Board of Directors To Sit As Hearing Board

**Thursday, September 12, 2024 at 6:00 p.m.
Section 28 Hearing Re: 10 Lakeside Drive, Stoney Creek
Permit Application No. SC/F,C,A/24/40**

Hearing Report

RE: Hearing under Section 28.1(5) of the *Conservation Authorities Act* for an Application by Sayed Shakour for Development in a Regulated Area of Lake Ontario at 10 Lakeside Drive, City of Hamilton (Stoney Creek) – Permit Application No. SC/F,C,A/24/40

Figure 3. Erosion hazard associated with Lake Ontario. The 10.00 m erosion allowance presumes a recession rate of 0.2 m/yr.

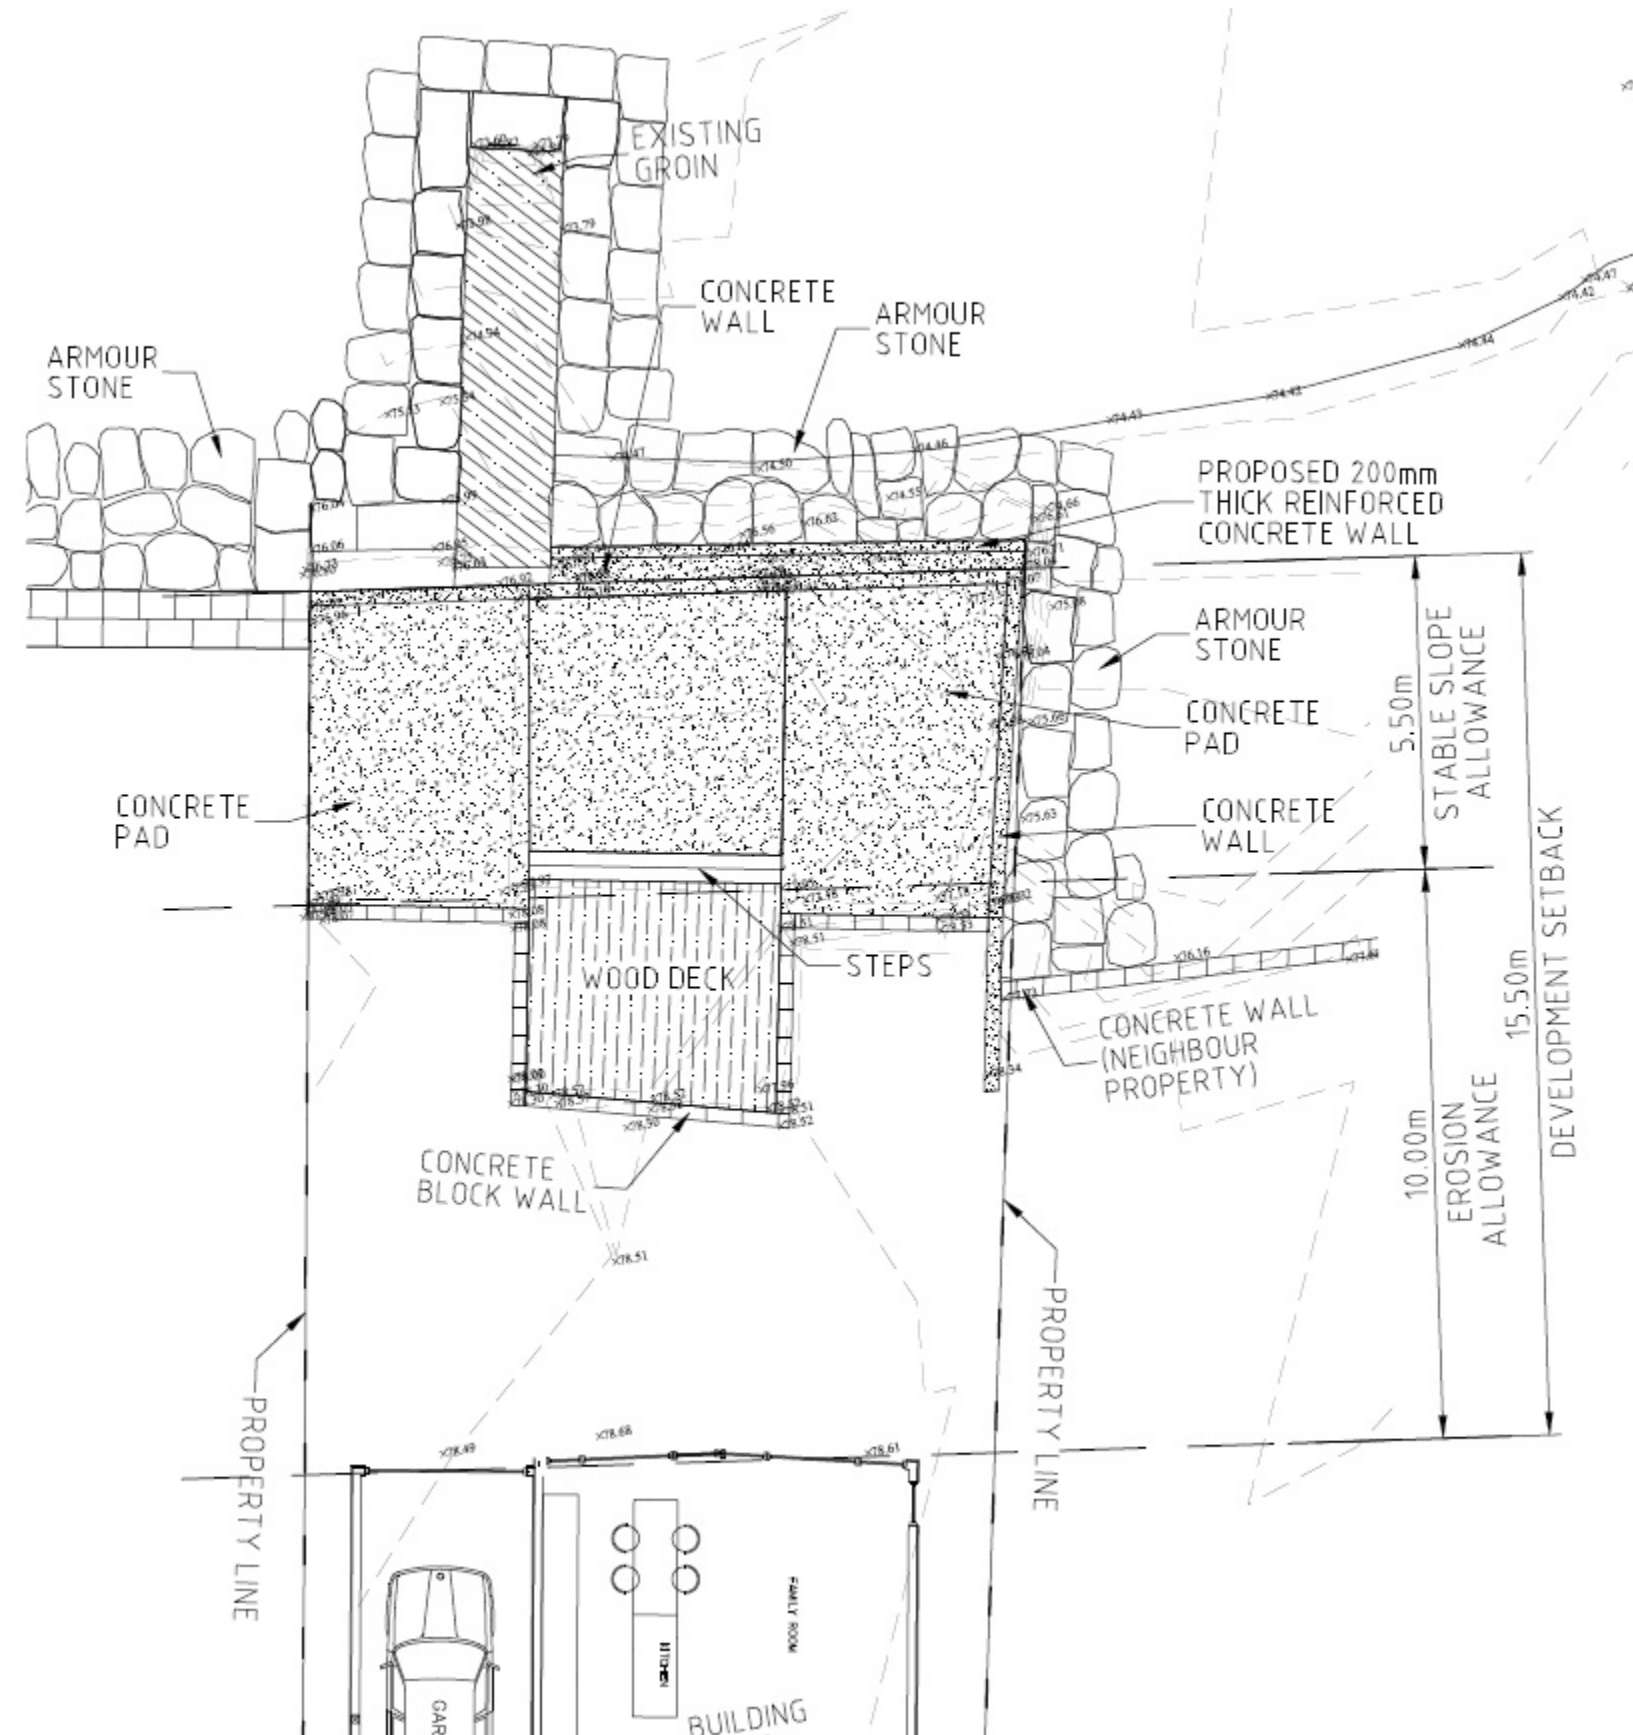
Concerns remain regarding the hazard setbacks related to the proposed second storey addition. Information provided in the HCA's new (draft) Shoreline Management Plan suggests that a recession rate of 0.3 m/yr may not be sufficiently conservative. In addition, the shorewall plans propose a tie-in to the existing shorewall at 8 Lakeside Dr, but if the shorewall on the adjacent property becomes damaged, there is still the potential for erosion from the flank. As described above, existing access to the property is constrained. Although there is no change to access relative to the existing conditions, future maintenance and construction on the shore will be a challenge.

Figure 4. Proposed site plan.

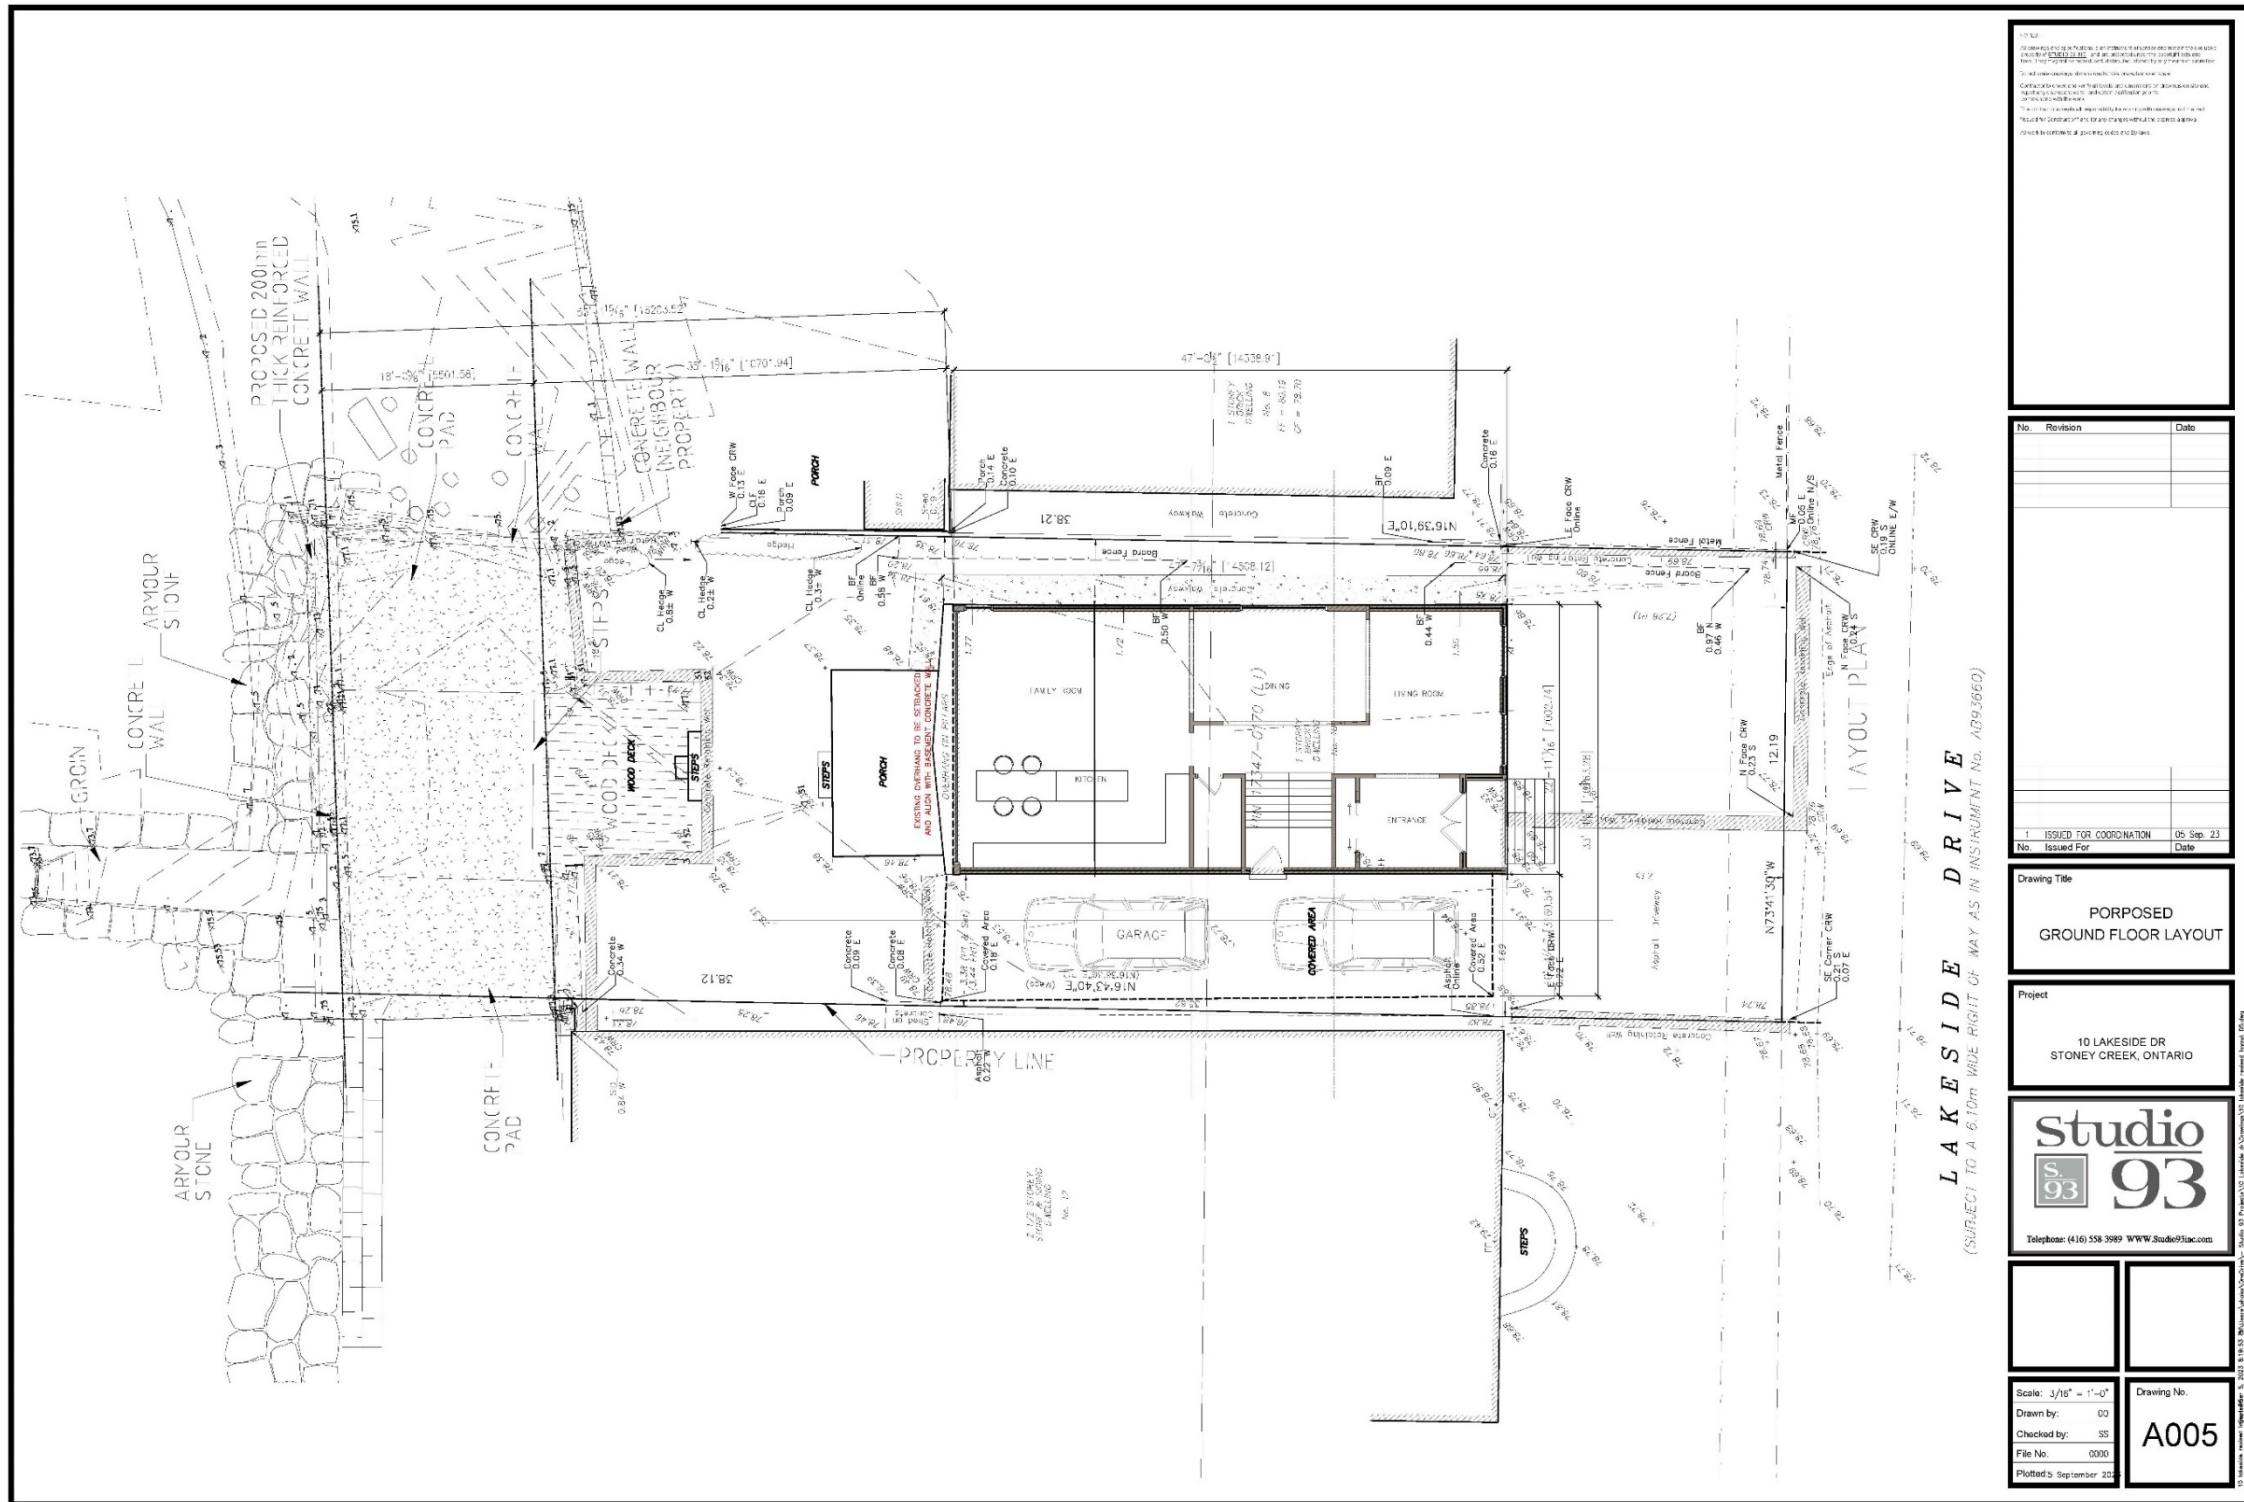
The subject application proposes development within the erosion hazard associated with Lake Ontario, and provides less side yard access than HCA policy recommends. Provincial and HCA policies take a preventative approach to addressing the potential risks and impacts associated with natural hazards by generally directing development to areas outside of hazardous lands. It is HCA staff's opinion the policy framework outlined in HCA's *Planning and Regulation Policies and Guidelines (October, 2011)* does not support the proposed development.

Figure 12. Proposed shorewall design.

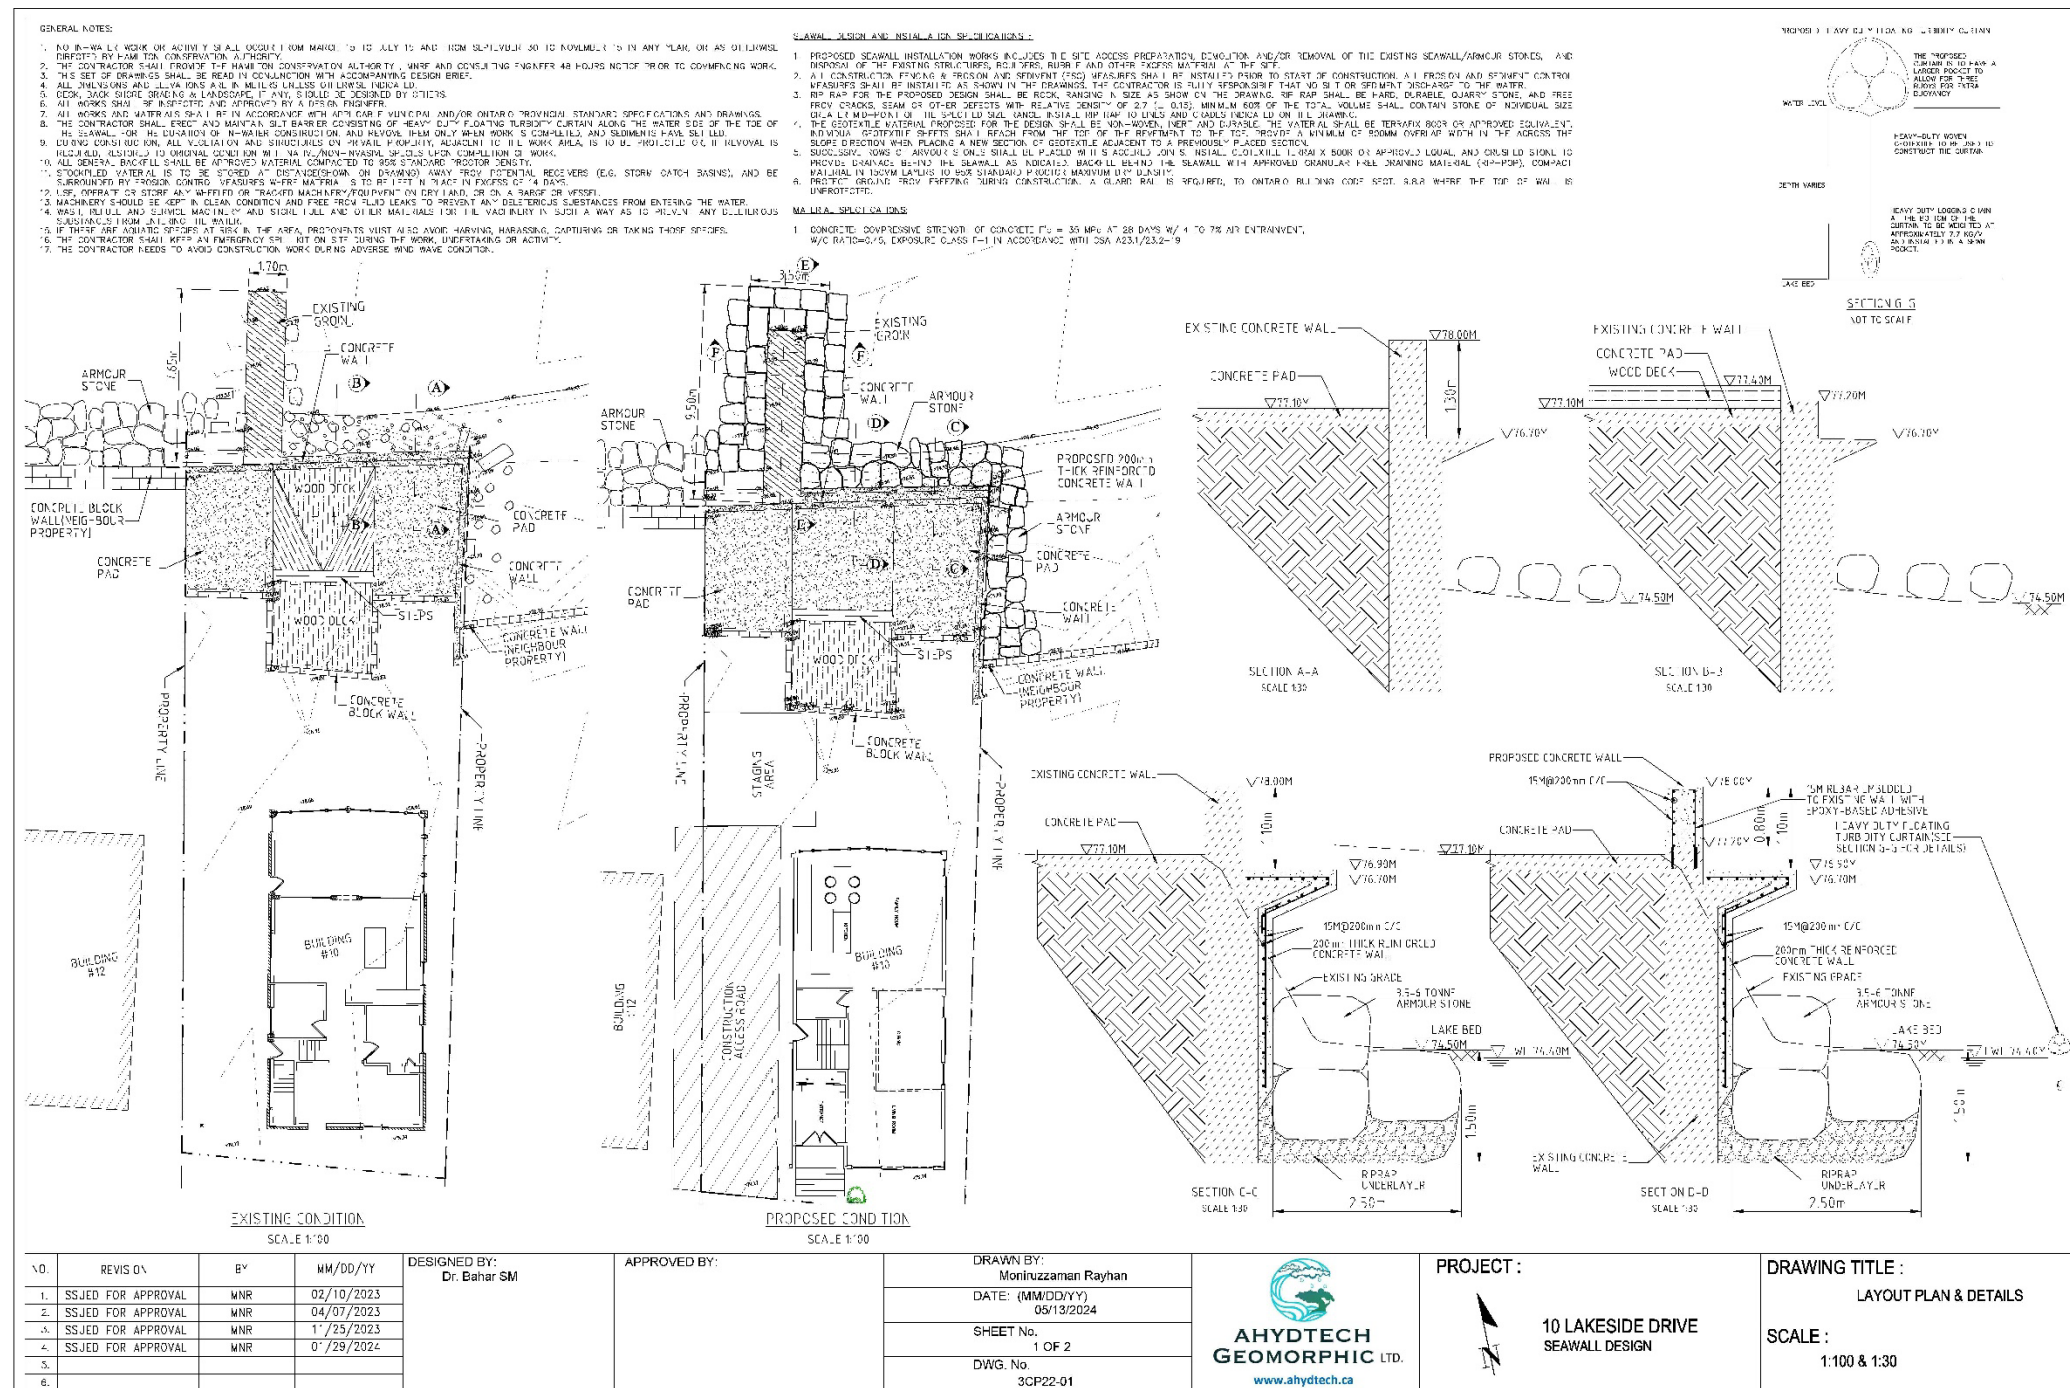
In addition, the shorewall plans propose a tie-in to the existing shorewall at 8 Lakeside Dr, but if the shorewall on the adjacent property becomes damaged, there is still the potential for erosion from the flank.
